JUBILEE PARK PHASE II APARTMENTS

SUMMARY

PROJECT ANALYSIS

SITE PLAN

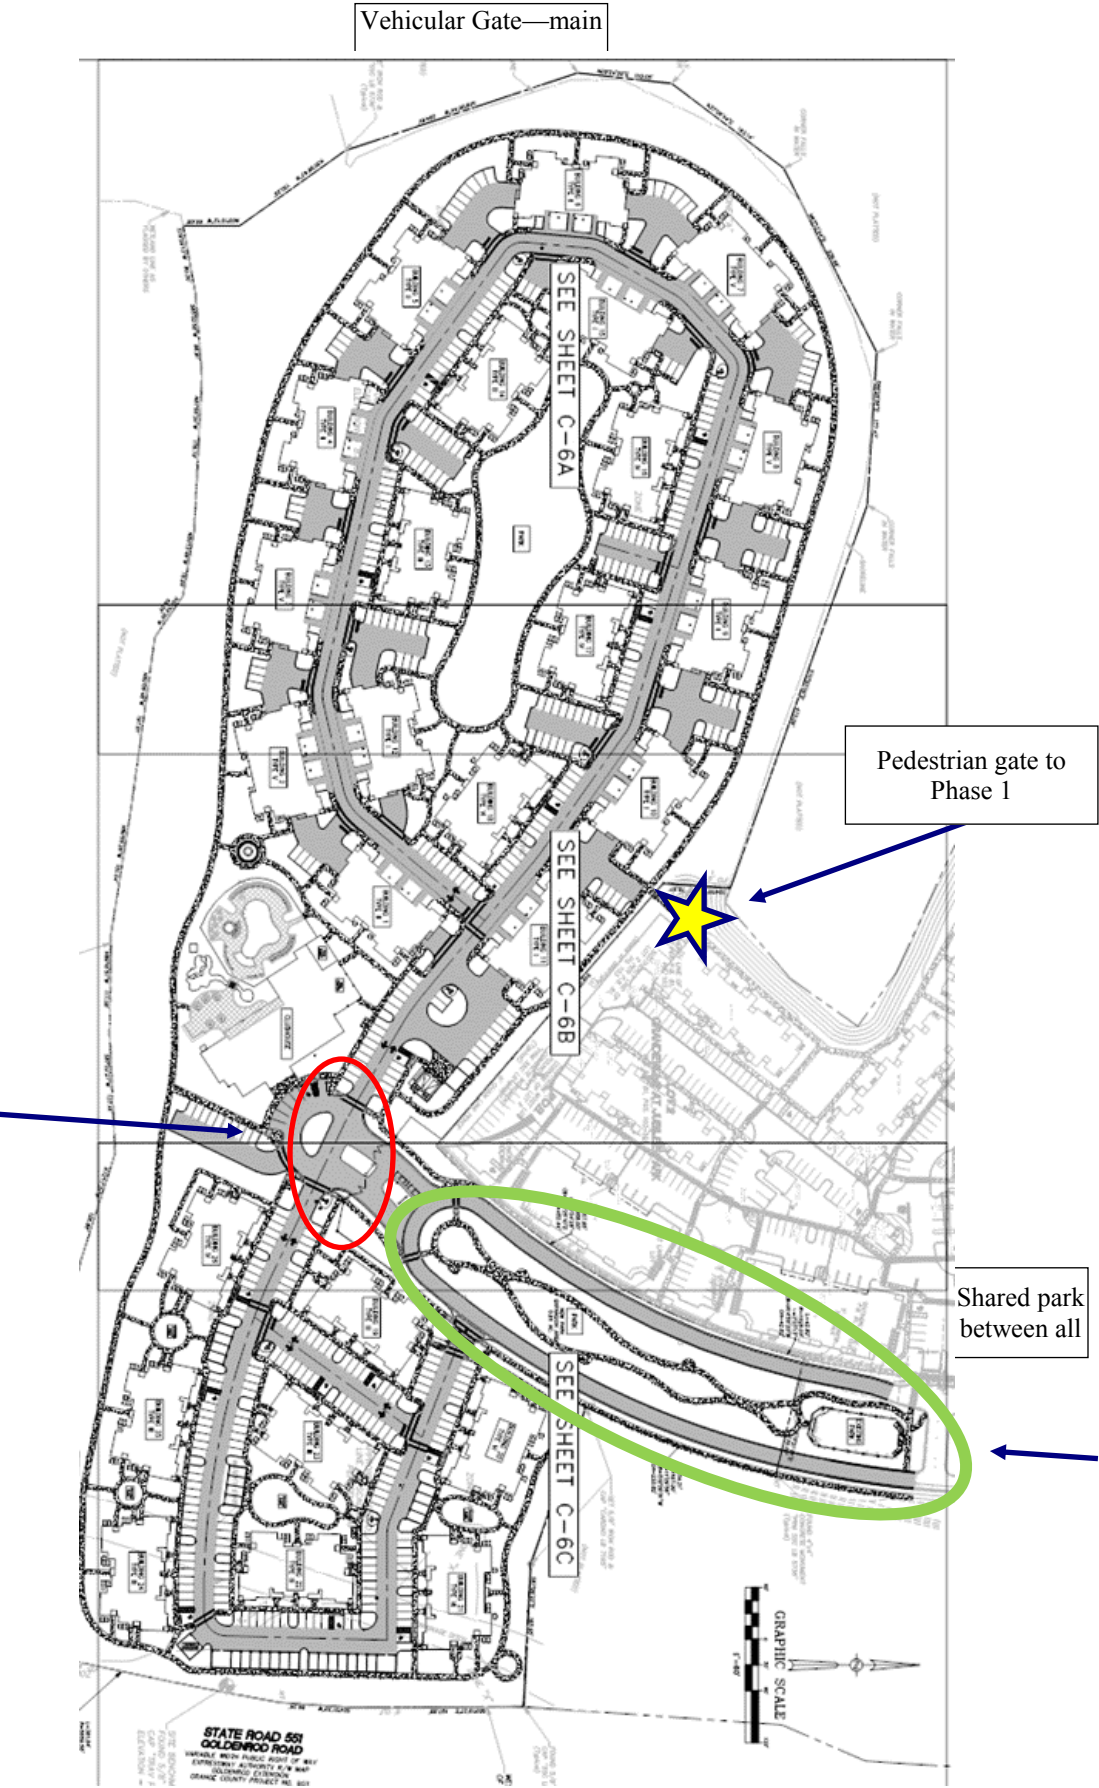
7. Continue the sidewalk from the south of the trash enclosure to the northwest, to the rear of the two parking spaces to connect to the sidewalk of Building 11, the sidewalk shall have pedestrian crossings where it goes through drive aisles. A tree shall be required at this island as well.

12. Additional sidewalks maybe required at time of permitting review to complete the pedestrian circulation.
13. Tandem parking between building 11 and 10, eliminate one parking space to enhance landscape island. Landscape island are required to have at least 1 tree.

17. Eliminate parking near dumpster area and continue sidewalk with pedestrian crossing.
18. Additional landscaping shall be required south on the clubhouse pool.

29. Relocate a/c equipment from building 1 on the north side to the eastside
30. Relocate a/c equipment from building 22 on the north and south sides to the west side

31. Relocate a/c equipment from building 23 on the south side to the east side
32. Relocate a/c equipment from side of building 20 to rear of the building.

15. The proposed dumpster associated with building F (parcel 10) is not accessible for the truck, any pull out dumpster needs to be approved by Solid Waste prior to development.
